FIRE SAFETY INSPECTION REPORT

Amir Shirts Ltd (23.301720, 91.290824)

ACCORD ID: 12586

Date: 30th October, 2016

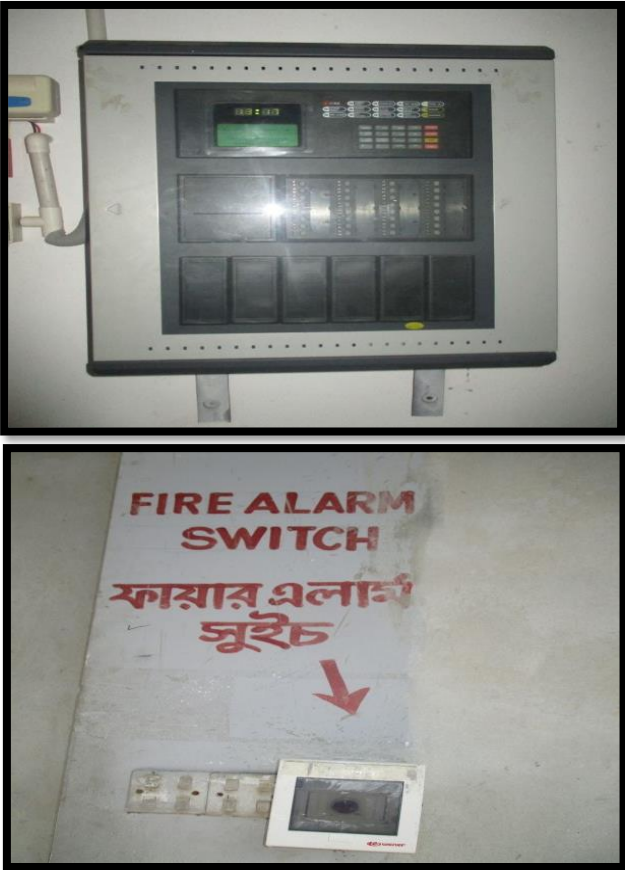
SI No.	Category	Findings	Required Action	Remediation Time Frame	Pictorial Evidence
19	Storage in Egress Path	Unit-2: Storage was located in the egress path.	Keep egress path and stair clear of storage.	Immediate	 <p>The top photograph shows an indoor egress path area with a blue barrel, a red bucket rack containing four red buckets, a yellow mop bucket, and a wooden chair. Blue arrows on the floor indicate the direction of the egress path. A sign on the wall reads 'AGAINST WOMEN'. The bottom photograph shows an outdoor egress path area with a blue barrel, a red bucket rack, a white bucket, and a red metal structure. A sign on the wall is partially visible.</p>
